UUWR26-07R

Cost Change Draft Determination: UUW Representation

Area of representation: Upgrading Boreholes

September 2026

Figure 1: [REDACTED] borehole abstraction data. Borehole 2 has been in operation since 09/07/2026

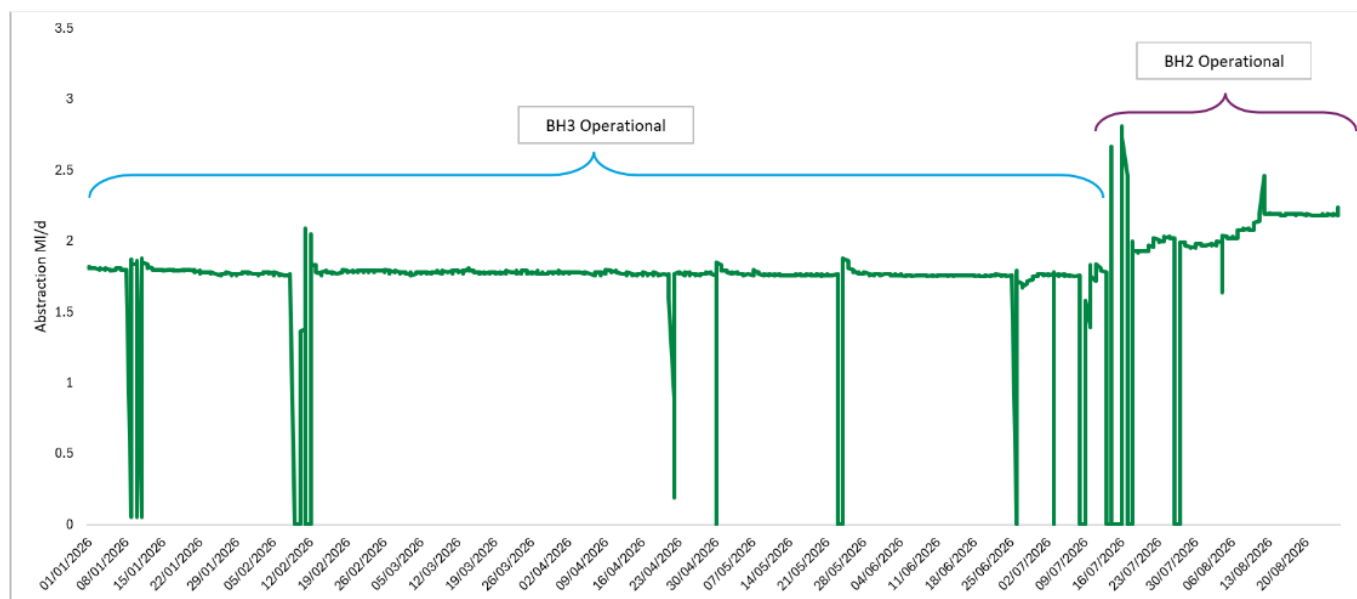
There are three boreholes at [REDACTED]: borehole 1 has been mothballed while borehole 2 and borehole 3 are both operational. Whilst [REDACTED] borehole 2 had not been used for some years it has been maintained as an operational source throughout this period. Indeed, borehole 2 has been in supply routinely since July 2026 whilst the pump in borehole 3 is awaiting replacement, as shown in Figure 1 below. The fact that the bore operated as a standby asset for some years should not preclude inclusion in the cost change process as it was operationally available and used, as demonstrated by the abstraction data this year. Borehole 3 is typically used in preference to borehole 2 due to the known degraded condition of borehole 2, but both are operational.

The condition of [REDACTED] borehole 2 was assessed by applying the condition assessment methodology provided with the asset health cost change guidance³. Both the borehole and headworks have been rated CG4 (poor). [REDACTED]

Borehole 2 is currently operational. Therefore the proposed remediation is associated with an asset health driver, rather than improving resilience. We ask that the original scope is reinstated in full for the [REDACTED] borehole 2 headworks replacement and borehole cleaning for a total of £0.3 million.
